**CROWN VICTORIA POLICE INTERCEPTOR (CVPI)
PACKAGE OPTIONAL UPGRADE KIT**

<ul style="list-style-type: none"> • BODY—PARTS AND PROCEDURE TO REDUCE THE POTENTIAL OF FUEL TANK PUNCTURES DURING RARE AND EXTREMELY HIGH-SPEED REAR IMPACTS • FUEL— PARTS AND PROCEDURE TO REDUCE THE POTENTIAL OF FUEL TANK PUNCTURES DURING RARE AND EXTREMELY HIGH-SPEED REAR IMPACTS 	<p align="center">Article No. 01-21-14</p>
---	---

FORD: 1992-2001 CROWN VICTORIA
LINCOLN: 1992-2001 TOWN CAR
MERCURY: 1992-2001 GRAND MARQUIS

Figure 1 - Article 01-21-14

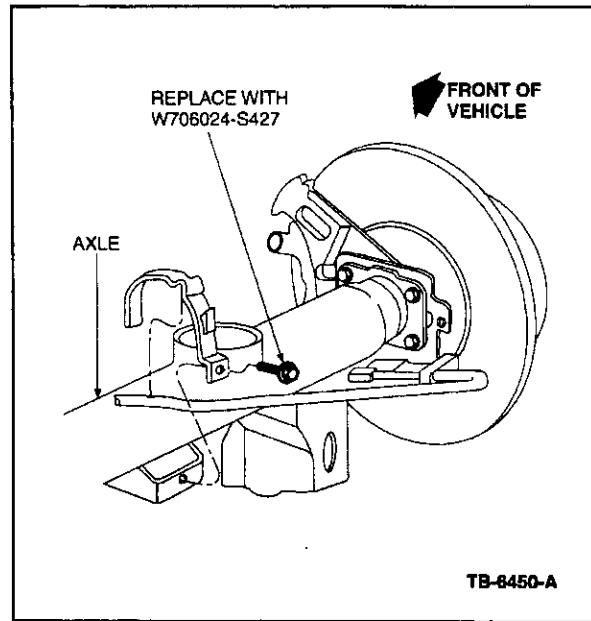
1. On 1992-1997 vehicles, replace Park Brake Cable to Axle attaching hex head bolt part N806900-S2 with round-headed fastener part W706024-S427. Model year 1998 and later vehicles are of a different design and do not use this bolt (Figure 1).

Figure 2 - Article 01-21-14

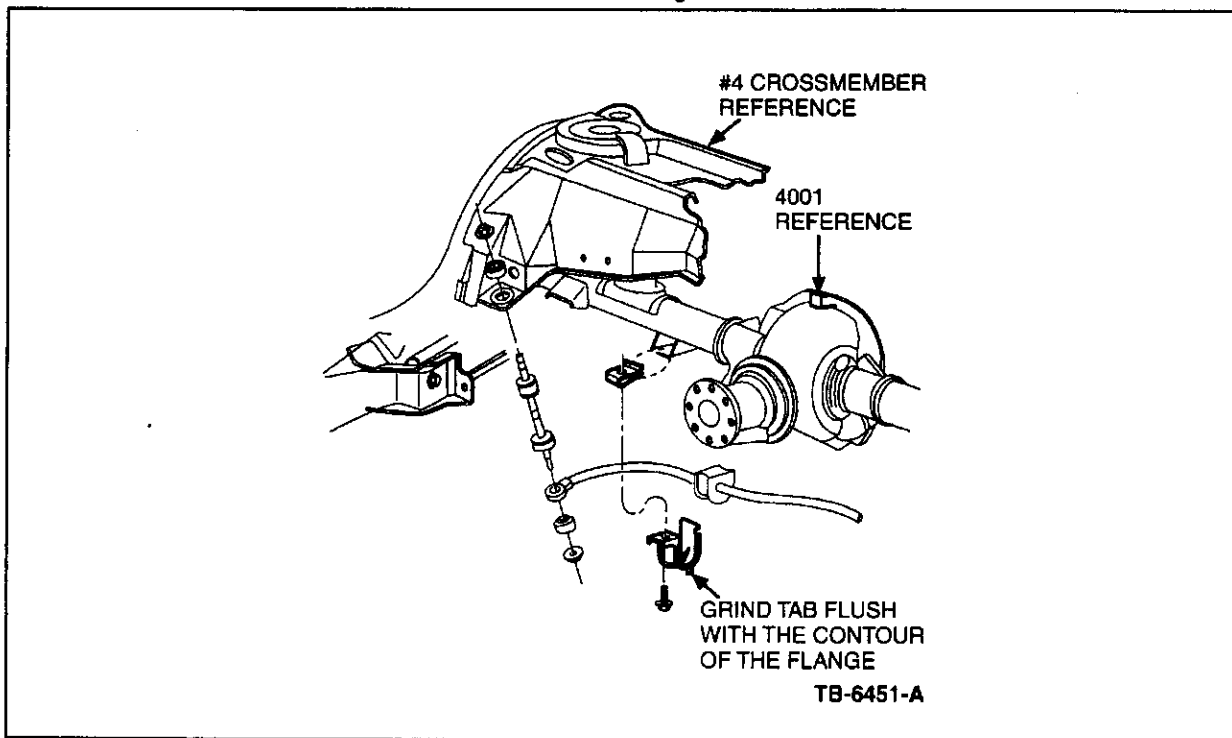
2. On 1992-2001 vehicles, use a die grinder or electric grinder with suitable carbide or grinding wheel to remove the 4 mm high by 6 mm wide tab which protrudes down from one flange of the rear stabilizer bar axle attachment "U" bracket. There is a "U" bracket at each end of the center section of the rear stabilizer bar (Figure 2).

The "U" brackets do not need to be removed from the vehicle.

The tab should be ground until it is flush with the contour of the flange.
